**REFL165 modification
by KA Aug. 2, 2011**

Title LSC Photodiode		Date Last Modified: 17-May-99	
LIGO Laboratory California Institute of Technology Massachusetts Institute of Technology			
Size: B	DCC Number: D980454-01-C	PCB / SCH Revision: B / 1	Engineer: J. Suina D. Ouimette
File: S:\SYSTEMS\LSCPHOTOD-1\FINAL\SCHEMA-1\8045401A.SCH		Date: 12-Aug-1999	Time: 16:56:25
		Sheet 2 of 2

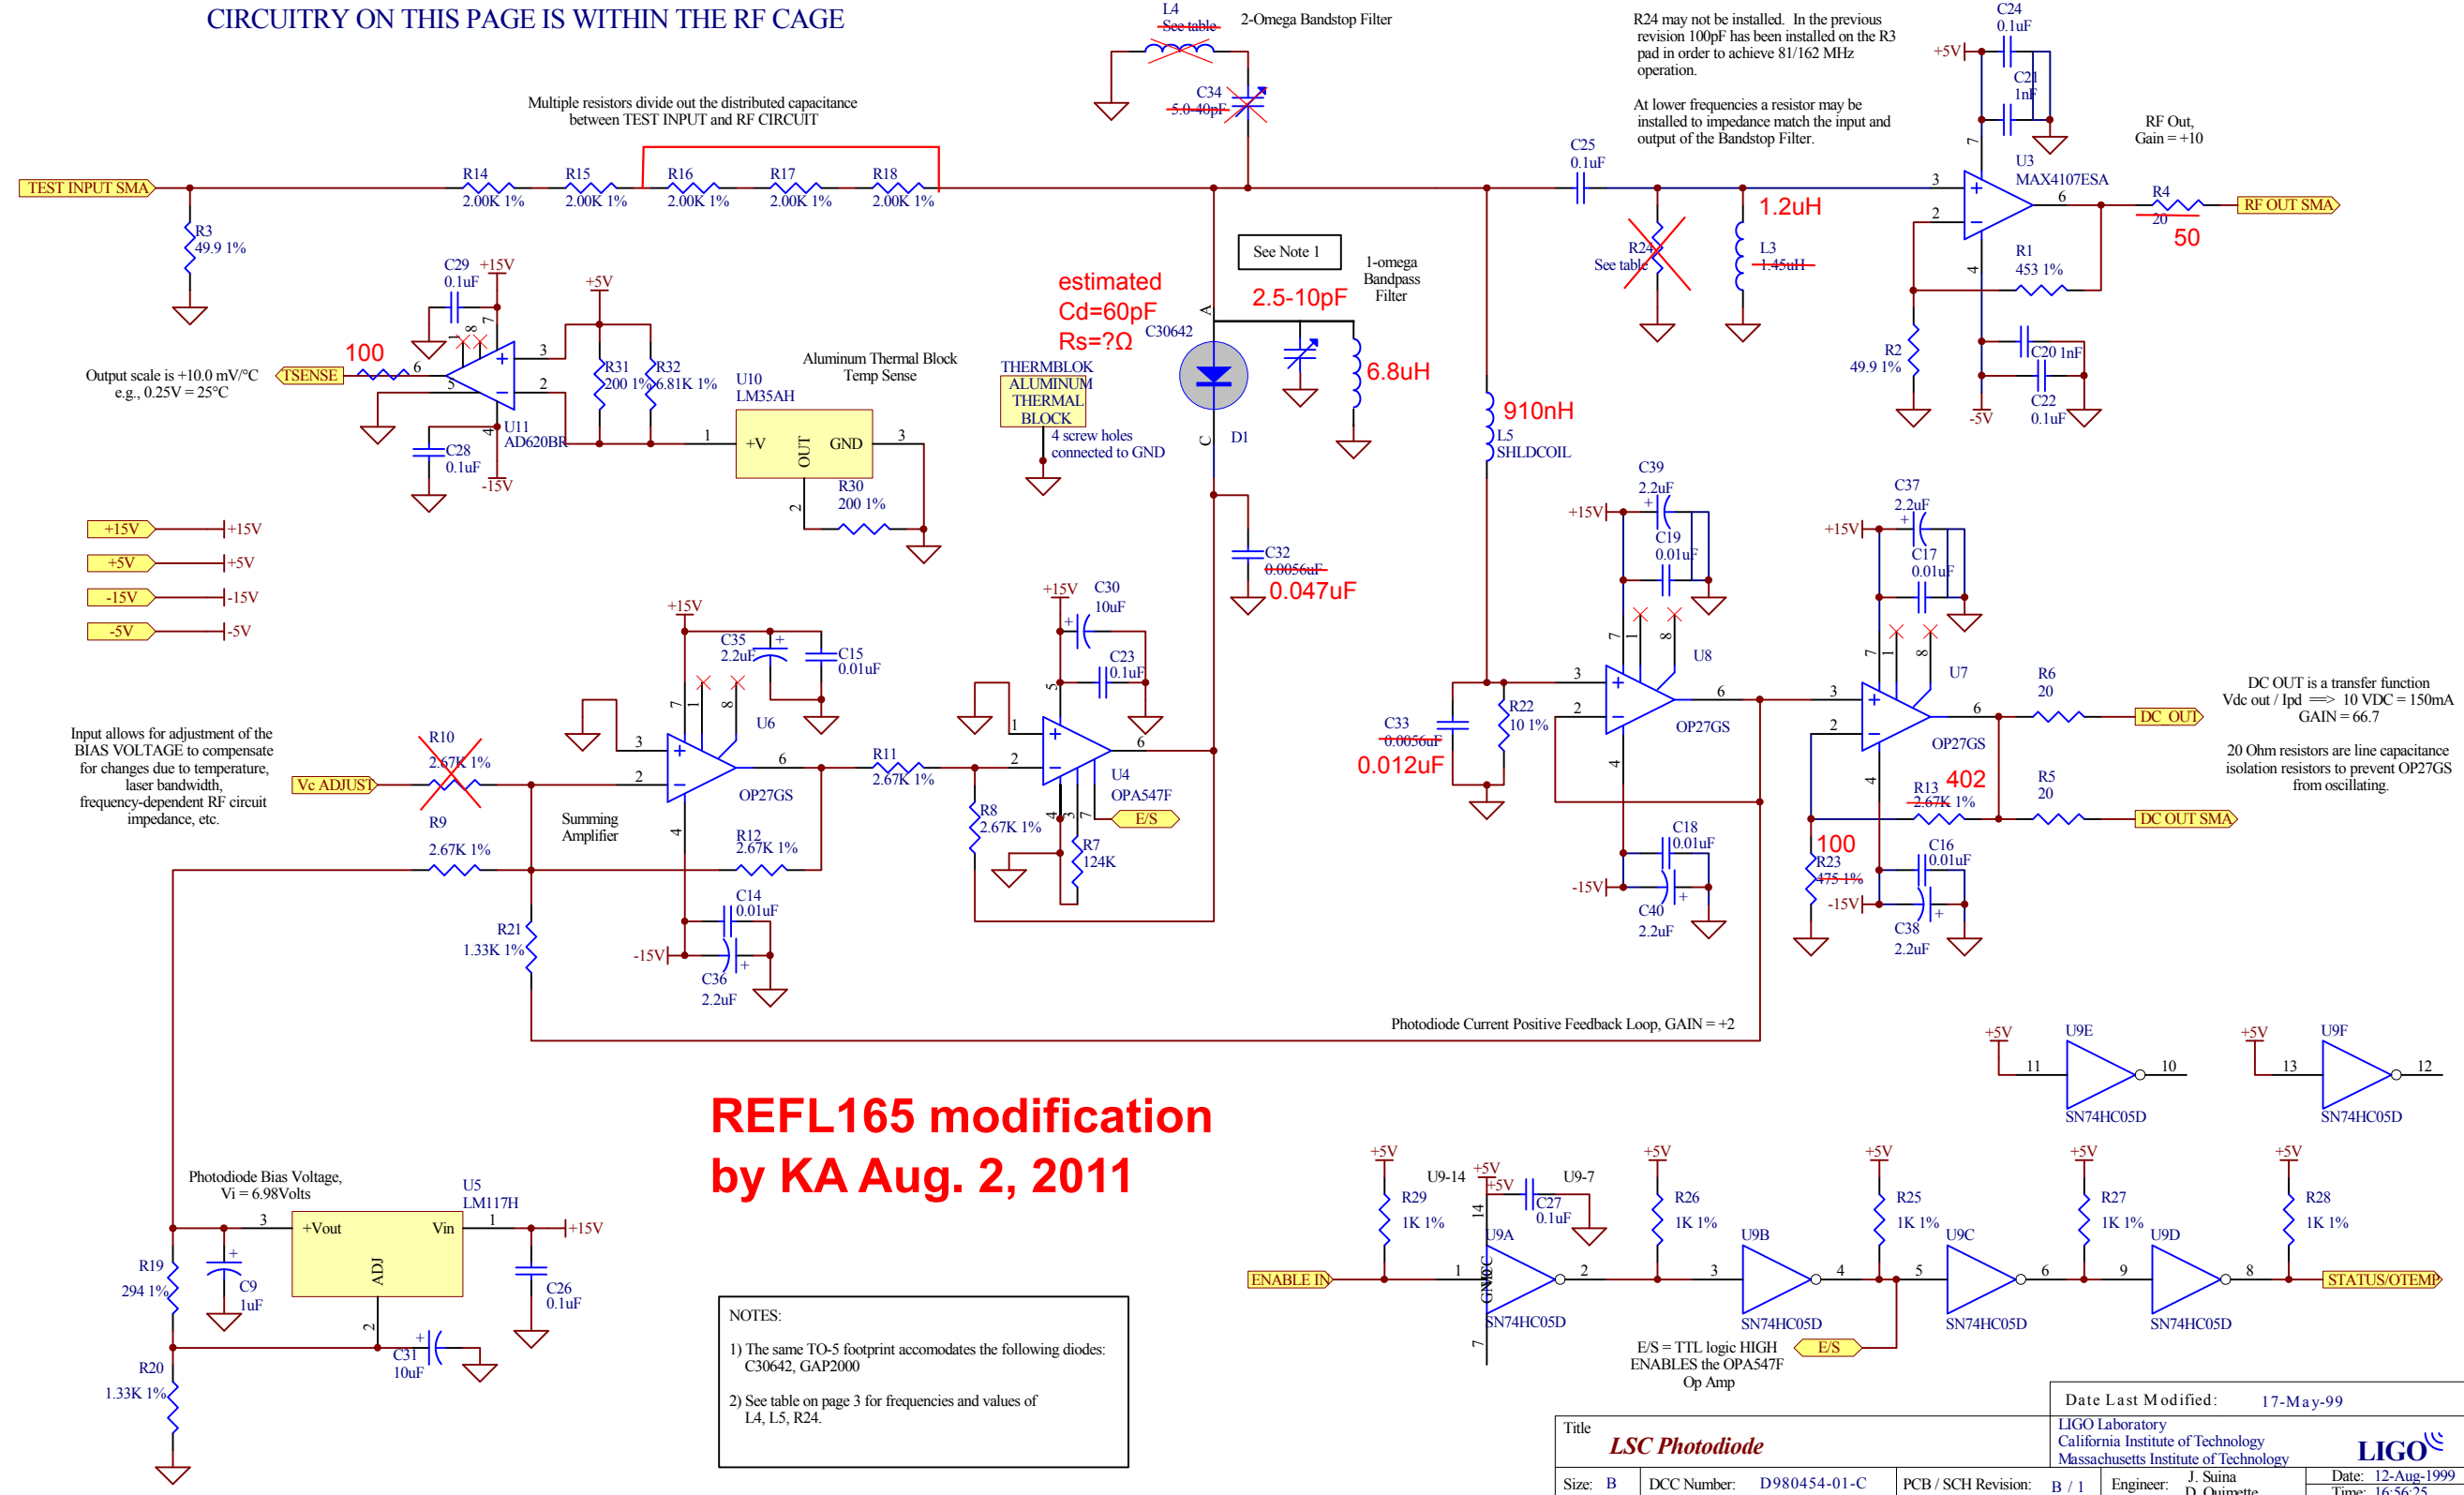
R24 may not be installed. In the previous revision 100pF has been installed on the R3 pad in order to achieve 81/162 MHz operation.
At lower frequencies a resistor may be installed to impedance match the input and output of the Bandstop Filter.
